Moser Pass
Case File: LU 2020-020 PUD/SUB
Final Development Plan

To: Planning Commission

Proposal: On March 7, 2023, City Council adopted Ordinance 2023-001 approving a Planned Unit Development (PUD) and Subdivision to be known as Moser Pass PUD (Case File LU 2022-020 SUB/PUD). The applicant now proposes a Final Development Plan and Final Subdivision Plat for the PUD. Like the approved project, the Final Development/Subdivision Plat proposes a 30-lot residential subdivision and PUD with a community park on a 12.36-acre property. The property is zoned Very Low Density Residential (VLDR) and is in the Southeast Sherwood Master Plan area. The applicant is proposing a minimum lot size of 10,000 SF and overall density of approximately 3.06-units per acre.

Exhibit 4

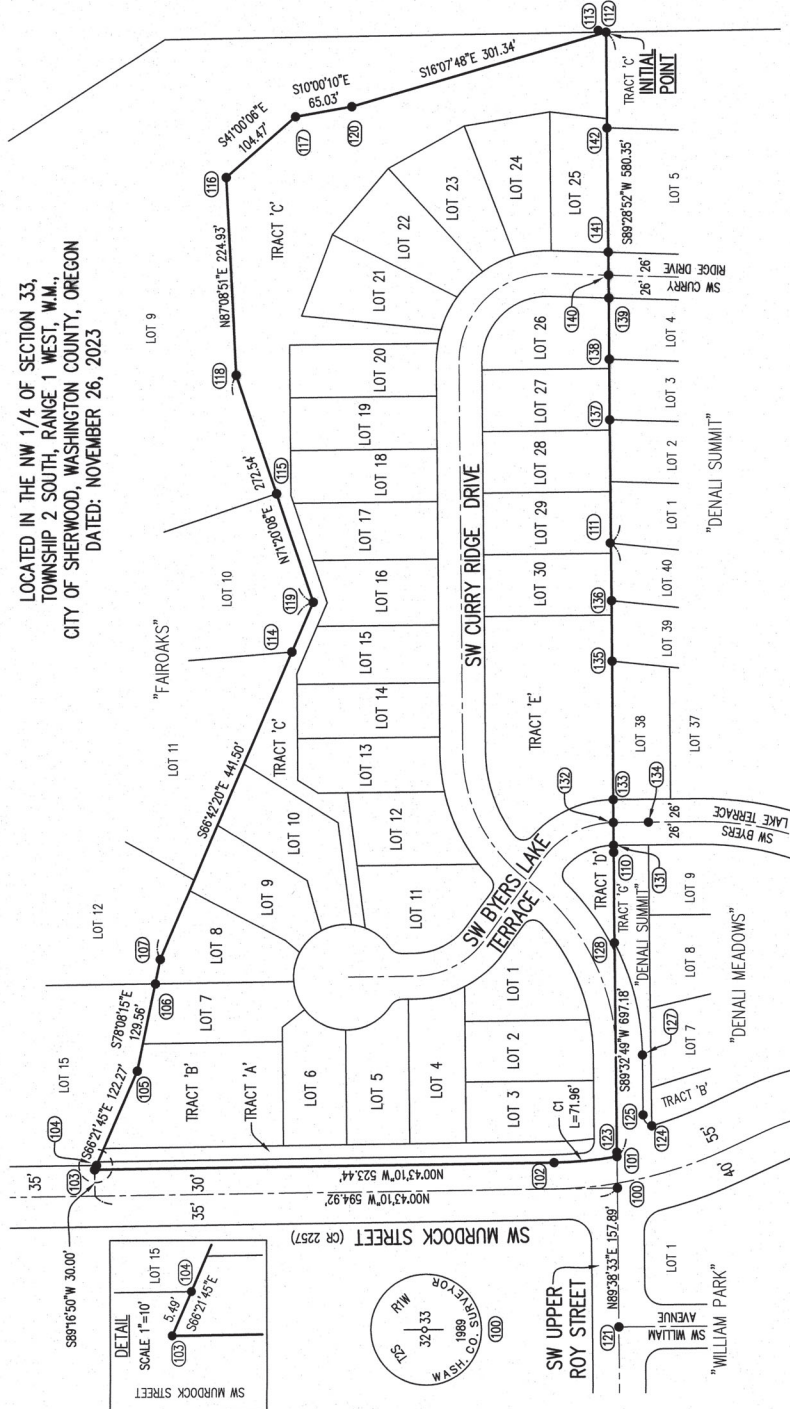
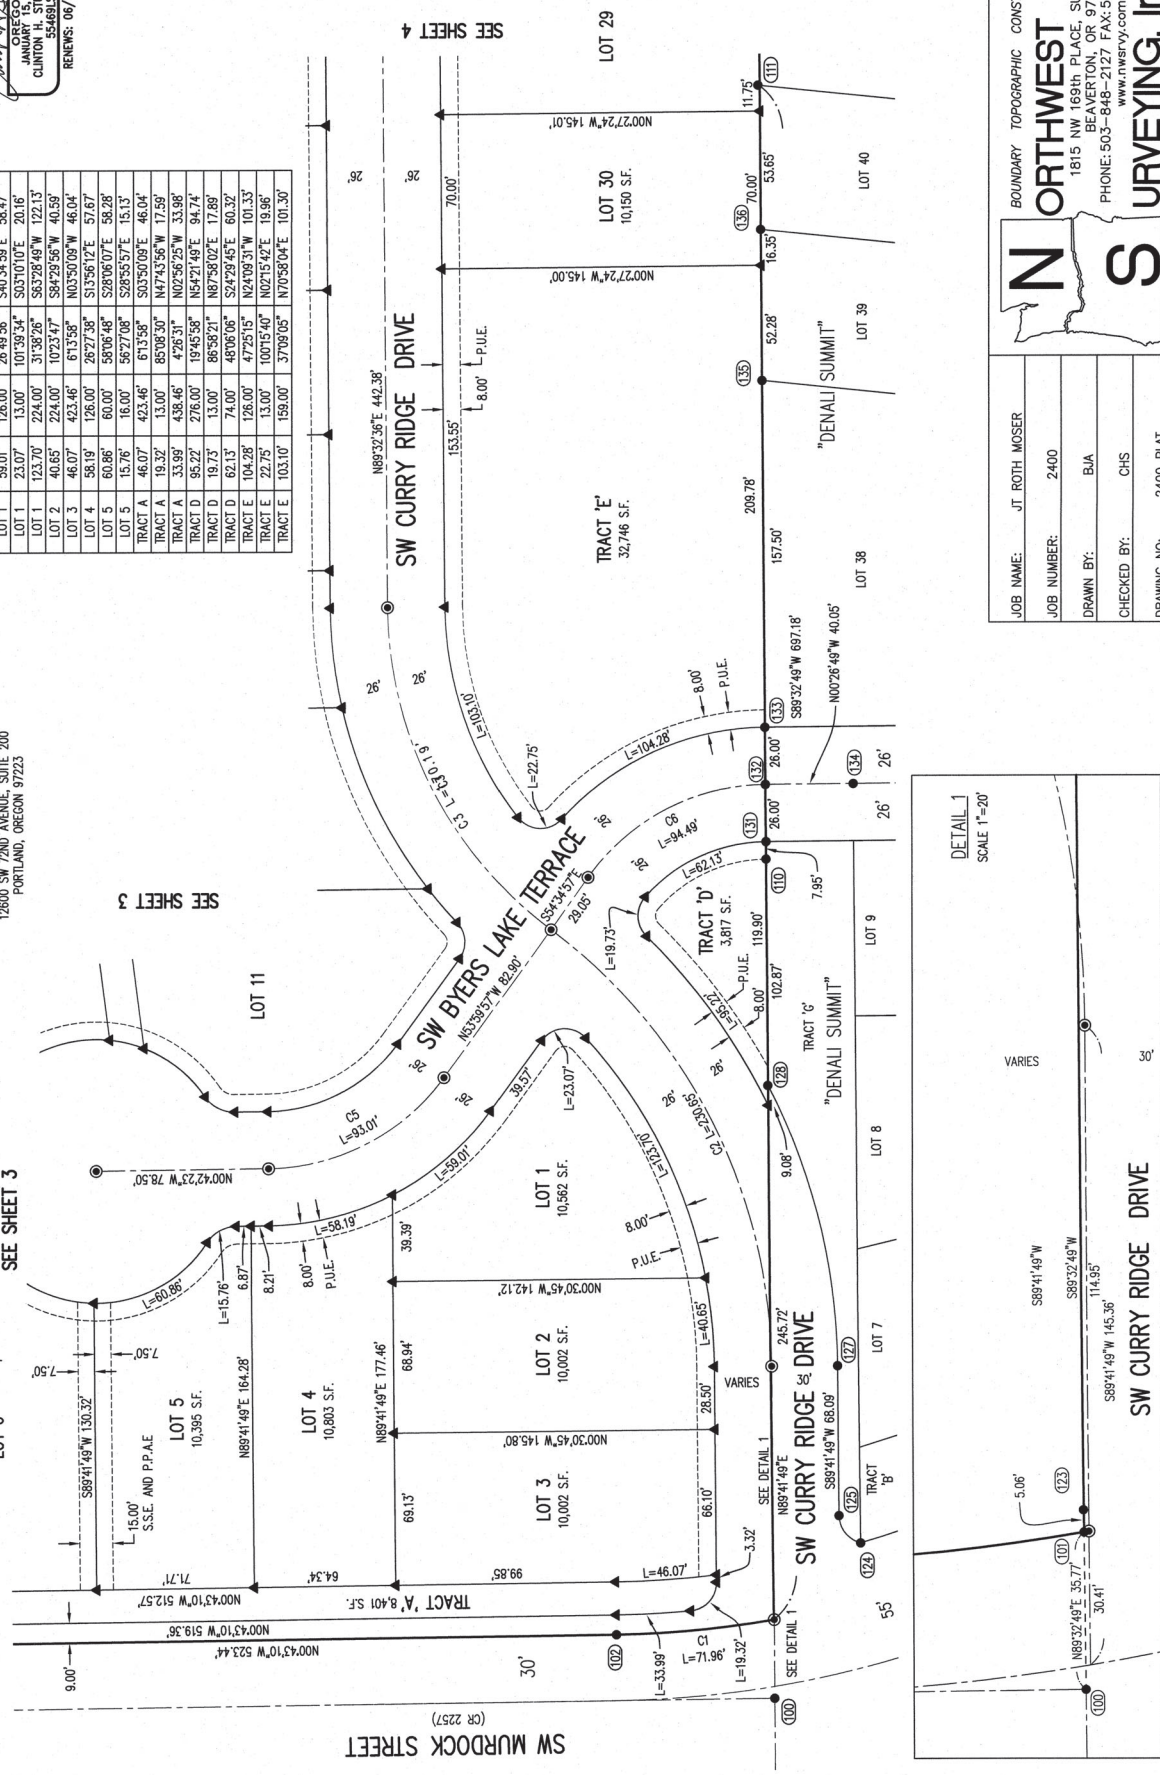
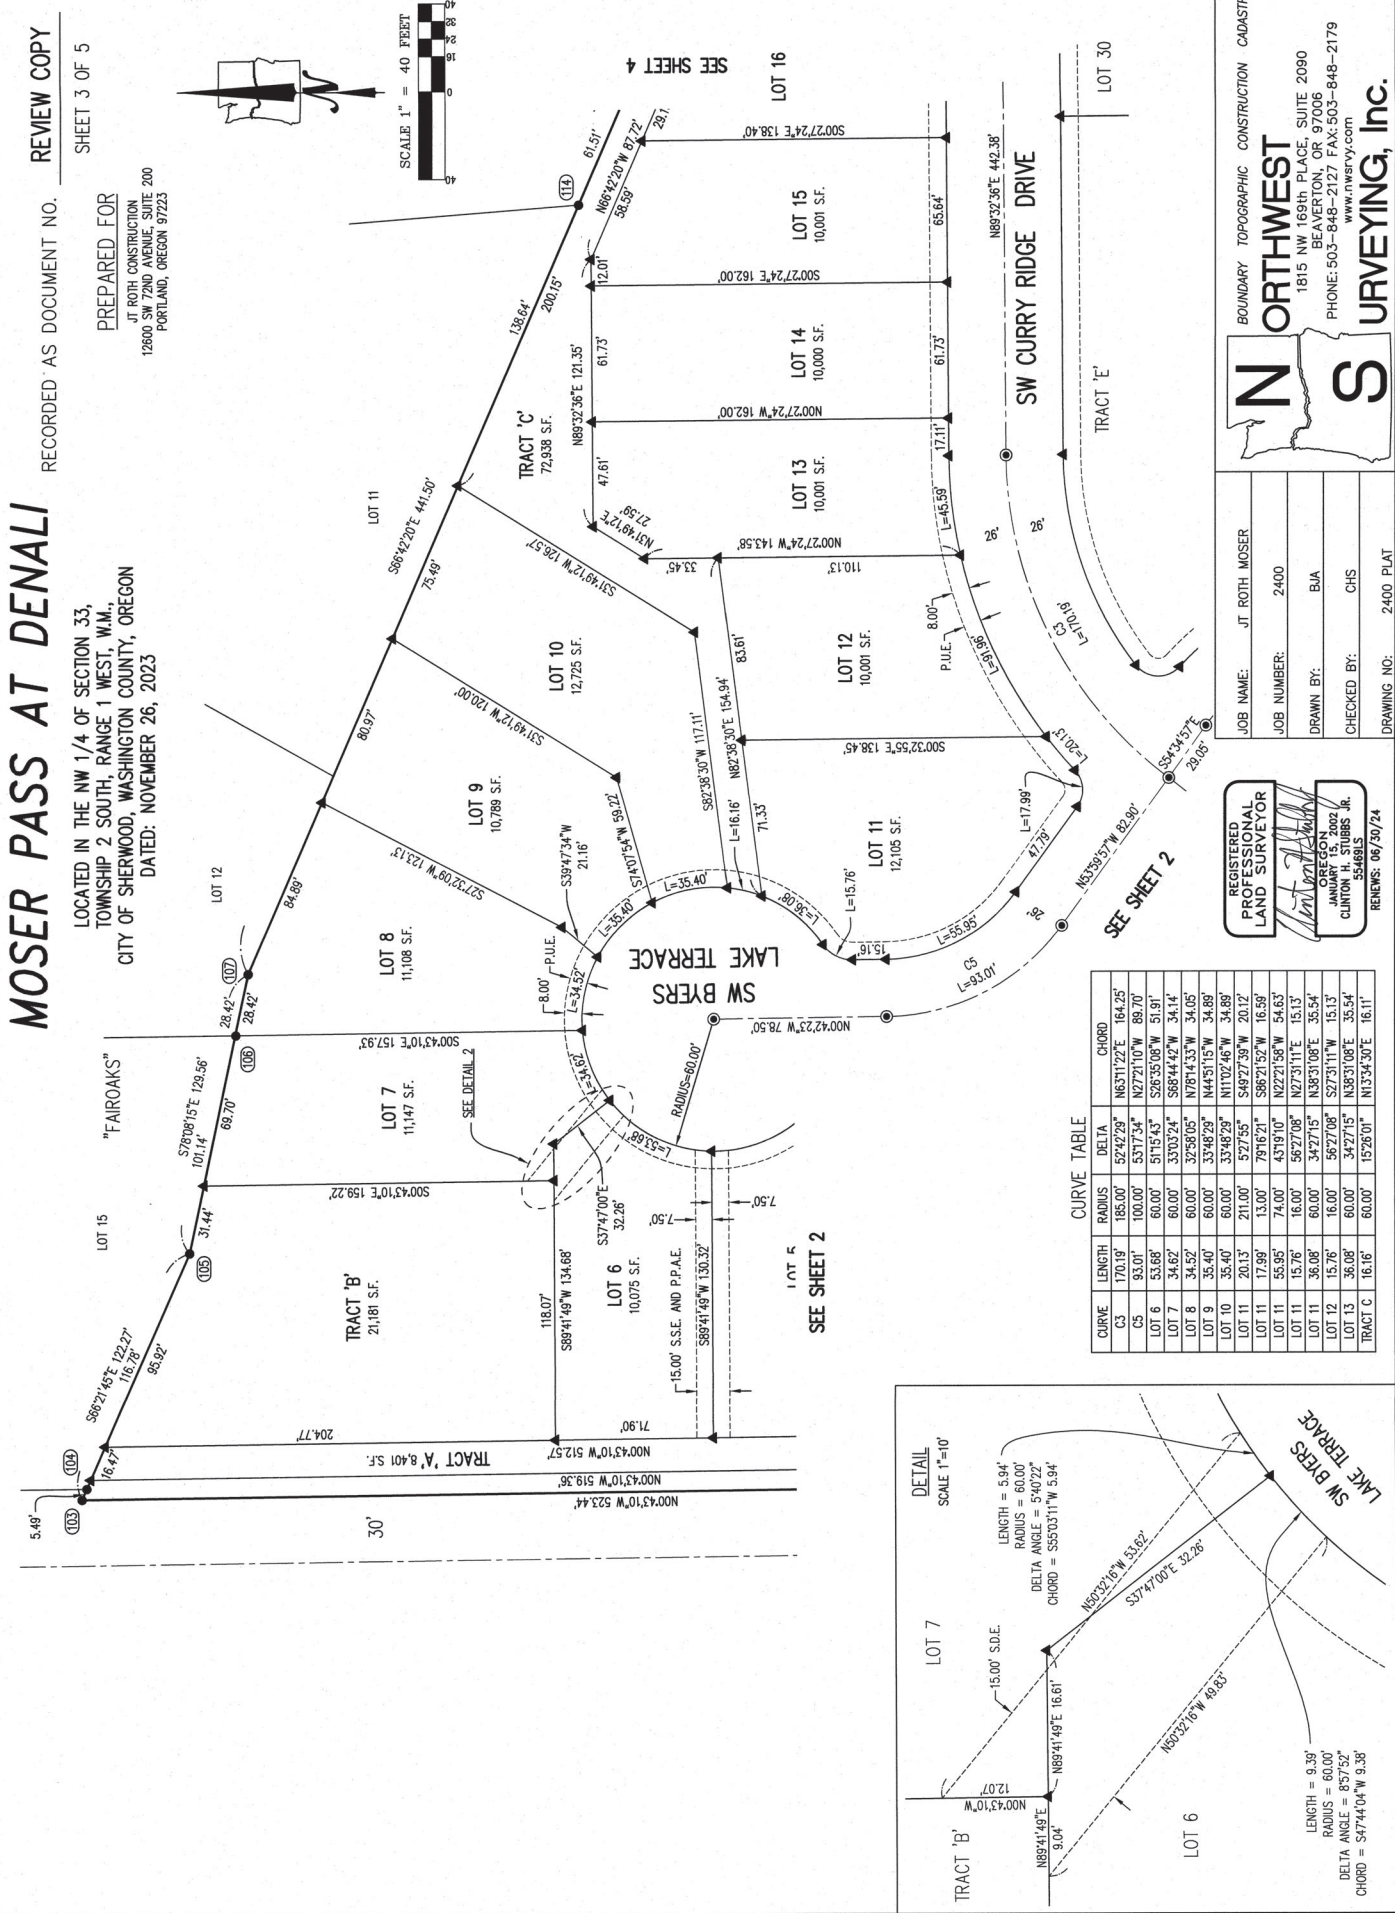
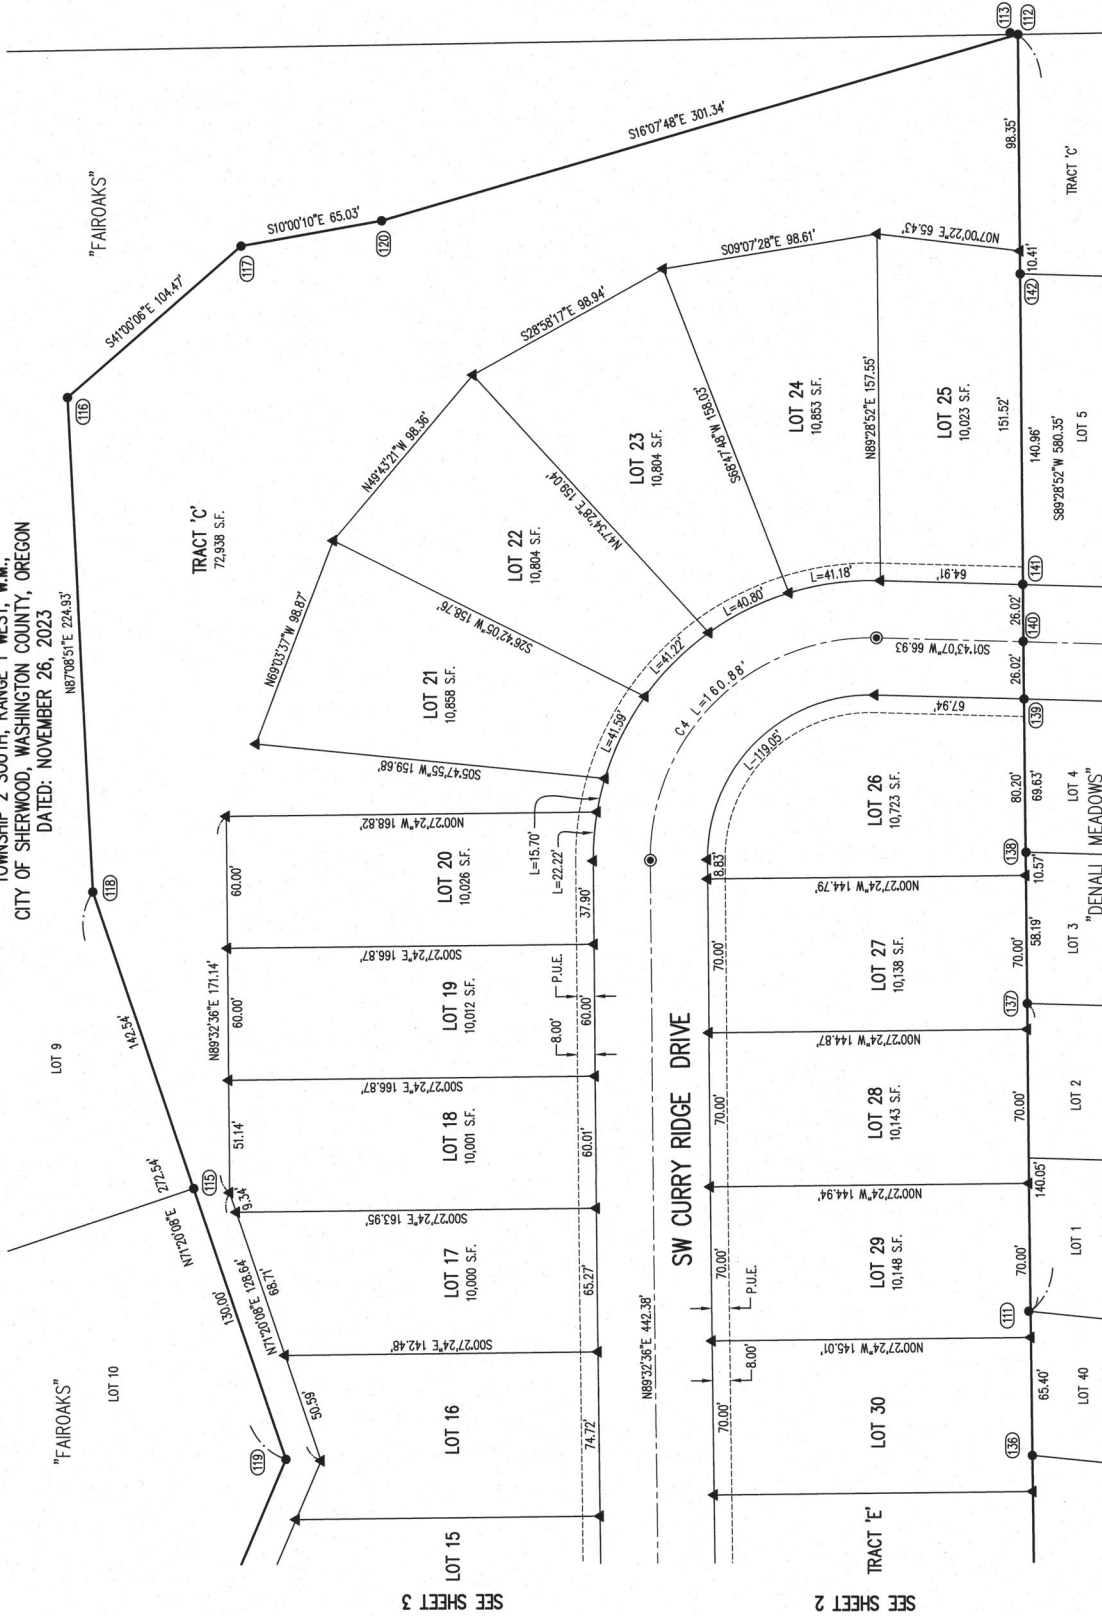
1. *Sherwood Engineering Department reviewed the plat stating that necessary easements for city utilities need to match the submitted engineering plans (see attached). The Plat should also label all the Open Space Tracts (Tract C and Tract D missing labels).*
2. *Plat Declaration Page and Plat Notes needs to be submitted.*
3. *The application identified the plat as “Tentative”. Please submit the latest with the above requested changes.*

Applicant Response: A final plat prepared by a licensed surveyor has been included with this submittal. The submitted plat labels all tracts, easements and ‘Tentative’ have been removed.

ELAT (ADA COMPLIANCE) AREA NOTE
THE PARK AREA HAS 29,000 SF OF FLAT (ADA COMPLIANT) AREA WITH A SLOPE OF 2.0% OR LESS.

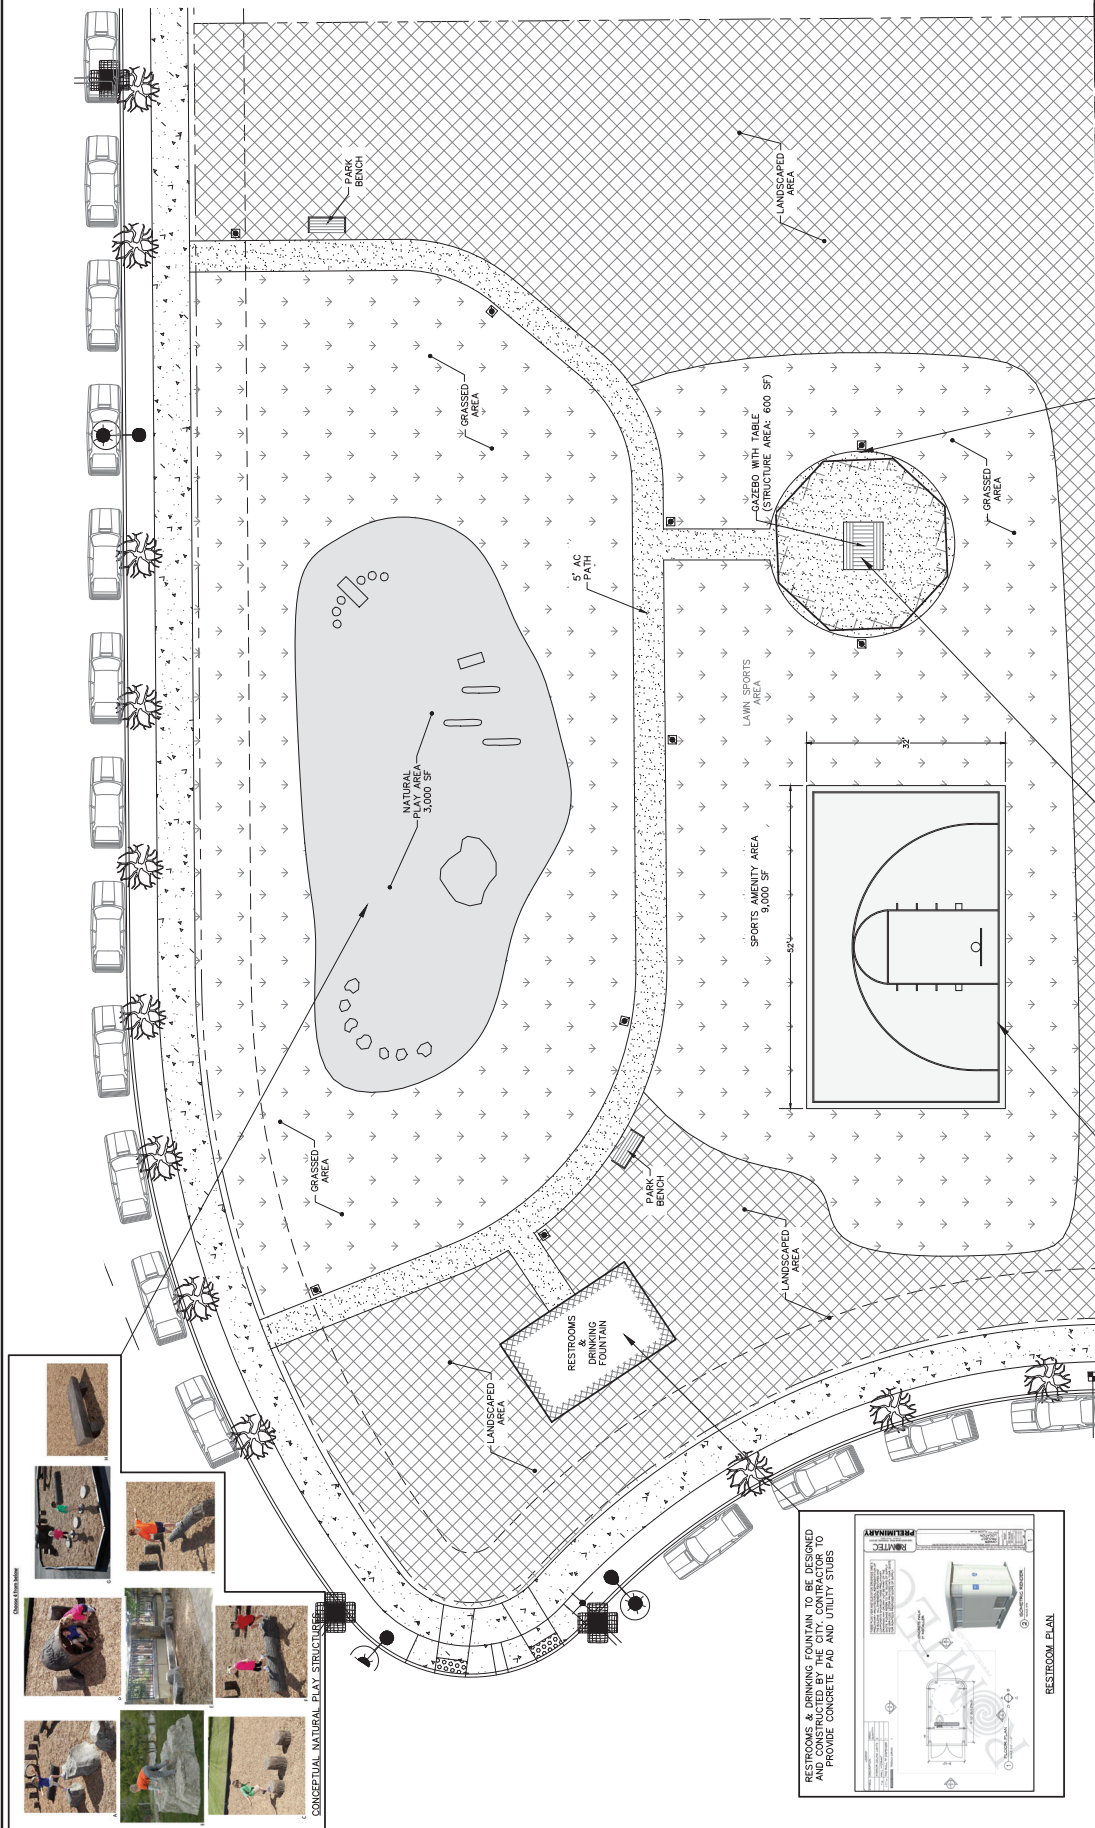
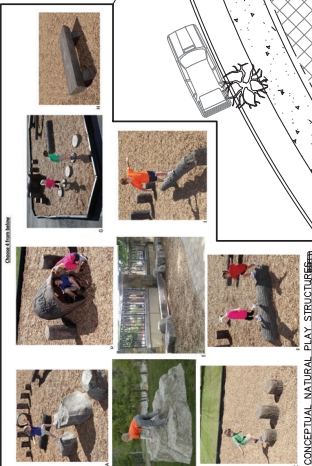
Submit a lighting plan.

Per the Sherwood's Parks Master Plan, the proposed bocce ball court and horseshoe pits are not considered sports courts. Examples of sports court are tennis, basketball, pickleball, and volleyball courts.

The gazebo needs to be a minimum of 600 SF. Please modify the plans to reflect a gazebo or other covered structure meeting the minimum of 600 SF.

Applicant Response: The lighting shown on the park plan exhibit (Exhibit D) is consistent with the submitted lighting plan to address the comment above. The applicant has removed the bocce ball court and horseshoe pits from the plan and has replaced those facilities with a basketball court to meet the desire of the City. The gazebo is shown to have an 'interior' area of 600 sf, includes a picnic table and lighting (lighting also reflected in the submitted lighting plan). The restroom detail has been added for reference and remaining Public Works conditions are ongoing.
